Transitway Station Design Safety Audit – Analysis of Findings

Final Report

Transitway Station Design Safety Audit – Analysis of Findings
Ottawa, Ontario, Canada

September 28, 2021

FIGURE 2: Probability of Redirection When Striking a 150 mm Barrier Curb at an Approach Angle of 5°

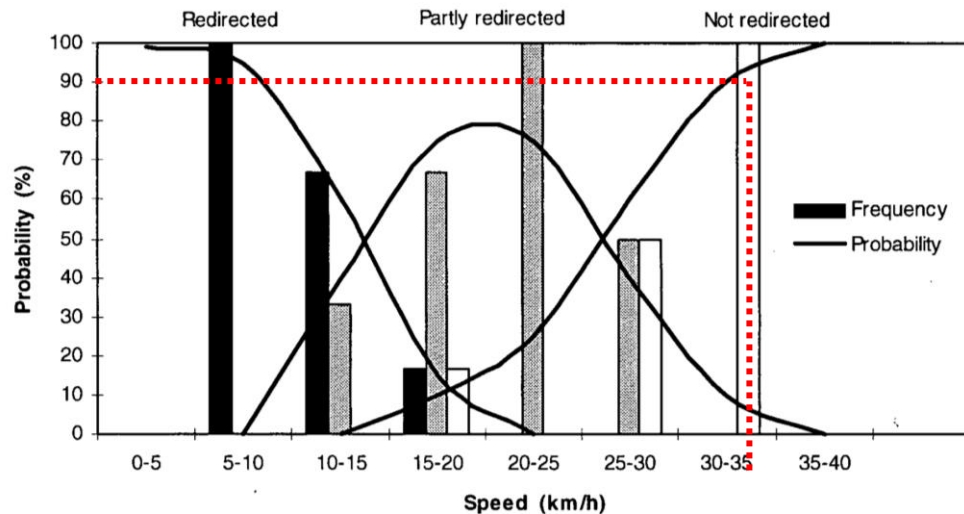
Auditor’s Suggestion: Replace the letdown curb on the approach end of the station platform with a 150mm high barrier curb. The letdown curb on the departure end of the station platform can remain. Note potential design guideline implication - locate curb letdown far side of station and curb height should be higher at BRT Stations, namely a raised platform 200mm (8”) to 250mm (10”) (reference to APTA BRT Stations and Stops Recommended Practice).

Whether a roadside curb is likely to redirect an errant vehicle, is dependent on many factors, including but not limited to, the curb height and shape, the angle of departure from the roadway, the vehicle speed at impact with the curb, and the vehicle specifications (mass, tire size, etc.). Full-scale tests on the redirection capabilities of 150 mm high barrier-type curbs indicates that these elements of the roadside have almost no ability to redirect errant vehicles at speeds above 26 km/h, regardless of the angle of departure (see Figure 2).⁶ Therefore, while the idea of replacing the depressed curb with a 150 mm barrier curb is intuitively appealing, the research indicates that this action is not likely to mitigate the identified safety issue.

It is recommended that OC Transpo take no action on relocating the service bay to downstream of the station due to the limited effectiveness of barrier curbs in redirecting errant vehicles. It is also recommended that, when the station is reconstructed, the guidelines for service bay placement and design conform to the prevailing best practices.

FIGURE 3: Severity Indices for Rock Cuts and Concrete Barriers

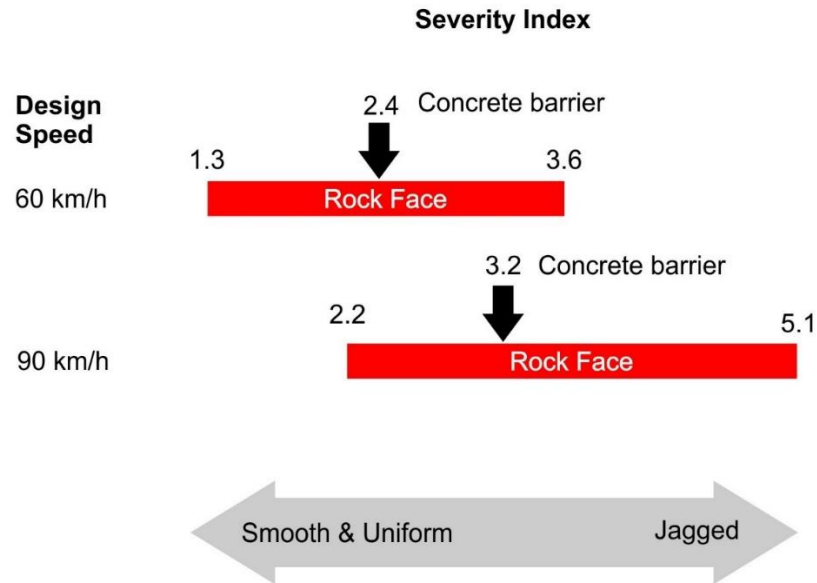
Auditor’s Suggestion: Install an appropriate length of need and taper of an anchored TL-3 F-Shape concrete barrier or a Cast-In-Place TL-4 F-shape concrete barrier. The barrier should be installed 1m offset from the edge line.

A jagged rock face increases the potential for higher severity crash in the event that an errant vehicle makes contact with the rock face. However, it is not axiomatic that an exposed rock face is a more severe hazard than a concrete barrier located 1.0 metres from the travelled way. According to the Roadside Design Guide the severity indices for rock cuts and concrete barriers are as shown in Figure 3.⁹

Whether the concrete barrier is a less severe hazard than the rock face is very much dependent on the smoothness of the rock face. The difference between smooth and jagged is not defined in the Roadside Design Guide. Moreover, because the proposed concrete barrier would be located closer to the Transitway, the barrier would result in a higher frequency of crashes than the exposed rock face. Hence, installing a traffic barrier may be detrimental to safety if crashes with the rock face are infrequent.

What can be concluded from the above information is that ensuring the rock cut is smooth and uniform is preferable to erecting a concrete barrier, from a crash severity and crash frequency perspective. The smooth and uniform rock cut has a lower severity index than a concrete barrier and would be located further from the Transitway.

It is recommended that OC Transpo review the rock cut at this location and conduct rock scaling and other maintenance to the rock face to provide as smooth a rock face as practicable. The cost and effort expended on this initiative should be commensurate with the fact that the Westboro station is to be decommissioned in the second quarter of 2022.

FIGURE 6: Luminance and Visual Function

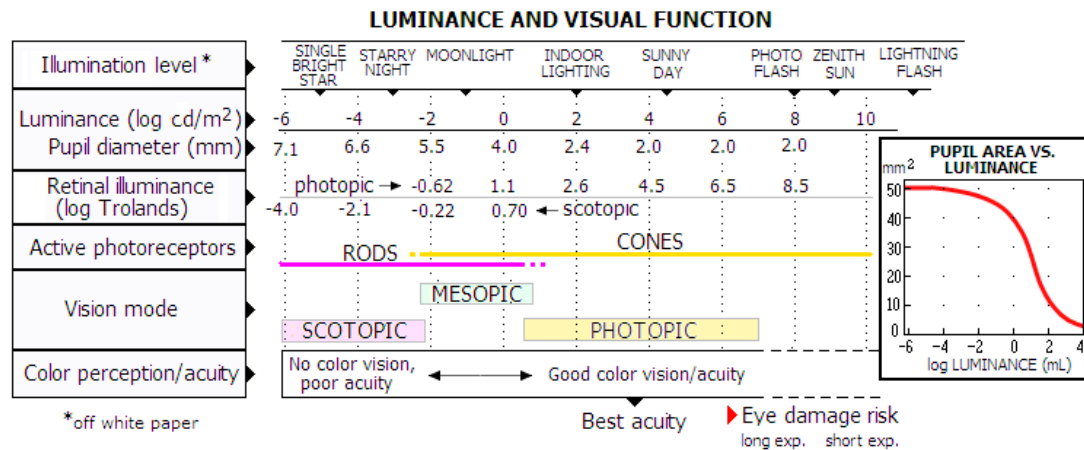
With respect to light adaptation, a shadow cast across the Transitway from a pedestrian bridge does not necessarily create a condition that results in visual impairment due to light adaptation. What matters in this regard is the magnitude of the change in the ambient light levels. While the road surface in the bridge's shadow will be markedly darker than the road surface in the bright sunshine, the change in the ambient light level is not as drastic because light from the sun is reflected off nearby surfaces, helping to illuminate the Transitway. More specifically, and in the simplest terms, light adaptation causes short-term visual impairment when an observer transitions rapidly from having to use photopic to scotopic vision (a rapid transition from light to dark) or vice versa (dark

to light). Different photoreceptors are used in light and dark conditions respectively, and a rapid transition can cause periods of temporary visual impairment as the eye switches from one type of photoreceptor to the other type (see Figure 6).

The ambient light in the shadow of the pedestrian bridge, even on the brightest day, is still likely to be in the range of typical indoor lighting. This being the case, operators on the Transitway would still be using photopic vision and visual impairment due to light adaption is not likely.
